Architectural Review Board

Staff Report (ID # 9515)

Summary Title: 250 Sherman Avenue: Public Safety Building (3rd Formal)

Birch Street Plaza Building Entry – View from Birch Street and Sherman Avenue

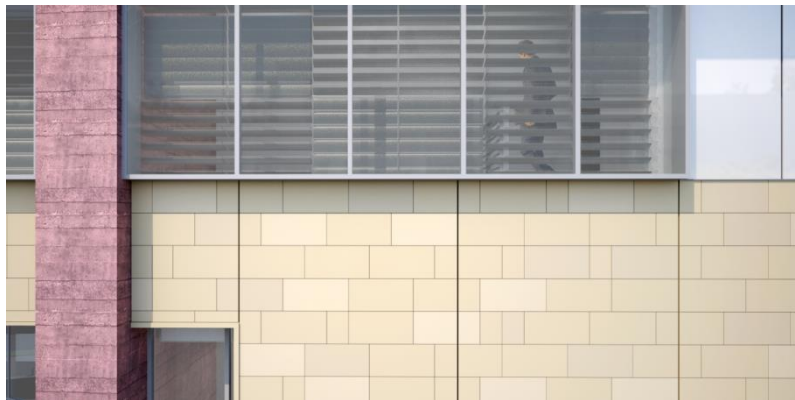
Windows project at level 3, wrapping the corner of the entry. The white glazed tile is proposed to be set back from pre-cast panels. Note the below left image has trees removed for clarity.
